Responses to Reference Report #1

This study proposed a method for the determining of warning water level for storm surge and investigated their variations in China, which could provide useful guidance for storm surge early warning and is of great practical significance. While, the manuscript should be more relevant as a scientific article and the scientific contribution of this study should be more clear. Specially,

Fig. 1 The location of Zhifudao tide gauge station in Yantai City, Shandong Province, China

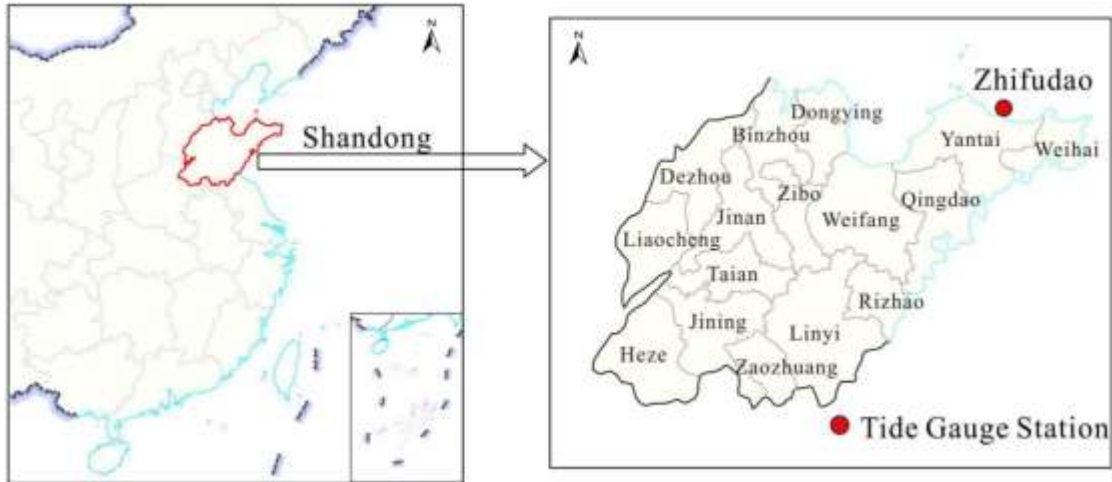
5. The compass (the North Arrow) was missing in all figures.

Response: Thanks for your suggestion. We have modified Fig. 1, Fig. 3, Fig. 4, Fig. 5 and Fig. 6 according to your advice, by adding the North Arrow to the above figures. The revised figures are as follows.

Fig.5 Spatial distribution map of H_s and H_d : a) H_s ; b) H_d

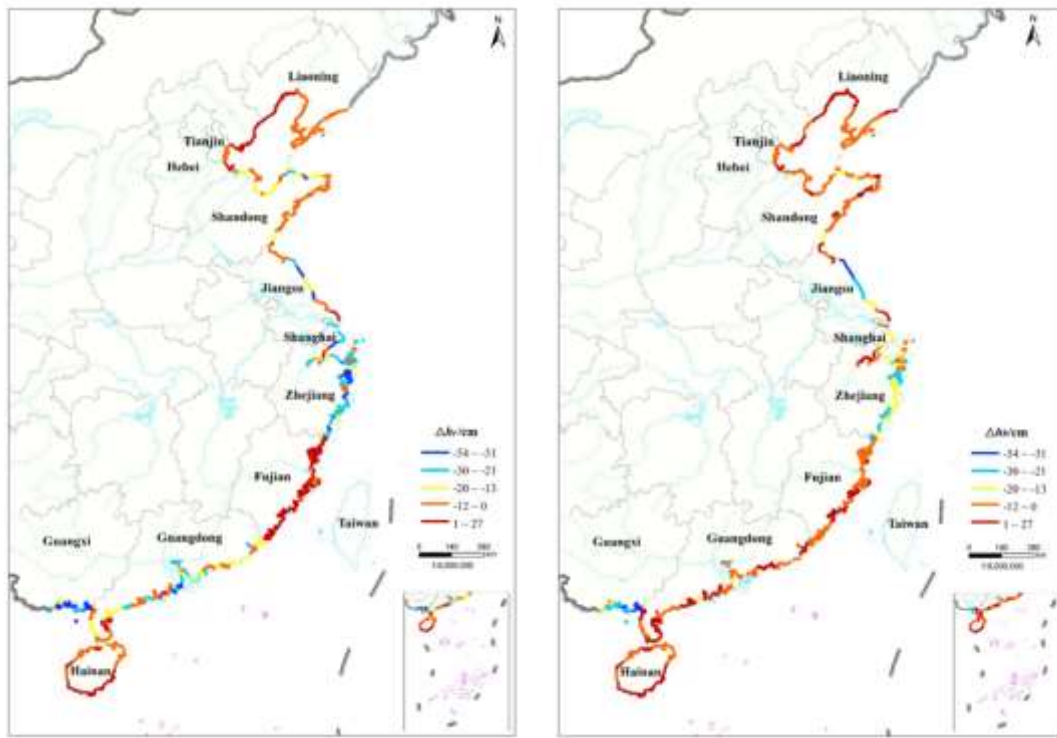
6. Figure 5 shows the spatial distribution of H_s and H_a . Please re-check the name of Figure 5 and make sure the name corresponding to the content.

Response: Thanks for your suggestion. We have modified the name of Figure 5 in the revised manuscript as below:

Fig.5 Spatial distribution map of H_s and H_a : a) H_s ; b) H_a
